From: Planning Admin
Sent: Tuesday, 22 December 2020 3:21 PM
To: Contact Us
Subject: FW: DA 0813/2020 - 318 Upper York St.

From: Andrew, Kate [REDACTED]
Sent: Tuesday, 22 December 2020 2:07 PM
To: Duncan Payton <Duncan.Payton@launceston.tas.gov.au>
Subject: DA 0813/2020 - 318 Upper York St.

From: Helen Statton [REDACTED]
Sent: Friday, 1 January 2021 6:51 PM
To: Contact Us
Subject: DA0813/2020
Attachments: DA0813 draft RH 01012021.docx

We are writing to you in response to the advertised notice of planning application, number; DA0813/2020 located at 316a Upper York Street, West Launceston.

Diagram 10.4.2A. Building envelope as required by sub clause 10.4.2 A3 (a)

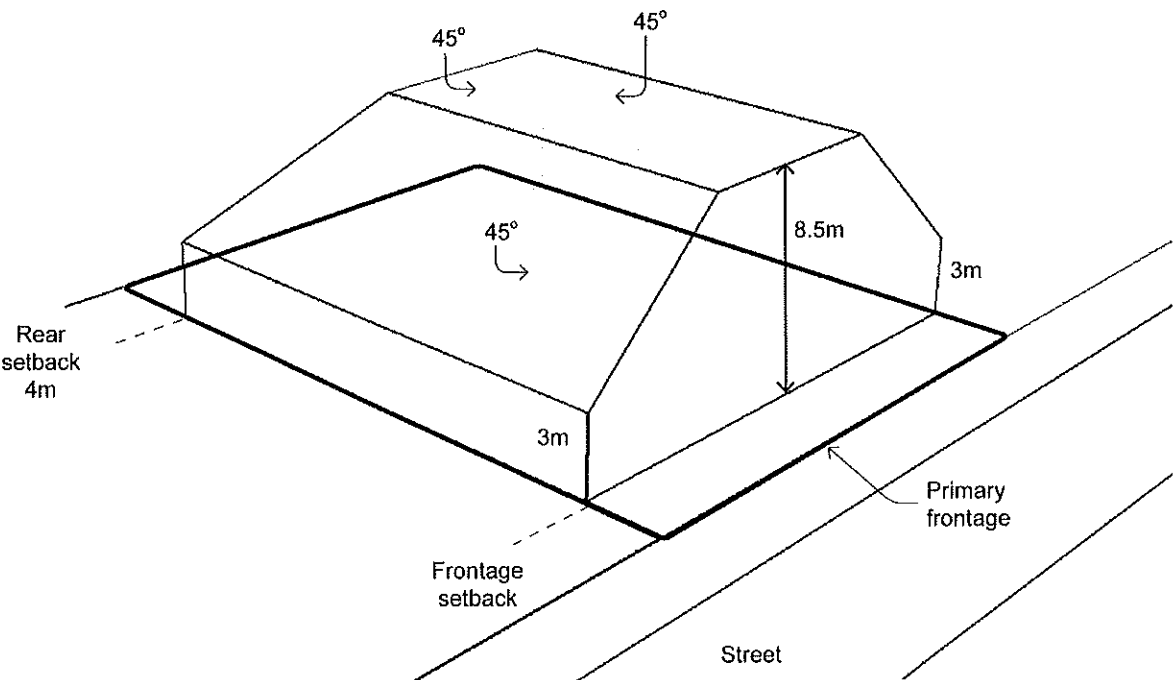
We are unsure if the proposed dwelling complies with this, mainly due the bulky nature of the building. We would like to discuss this further with you.
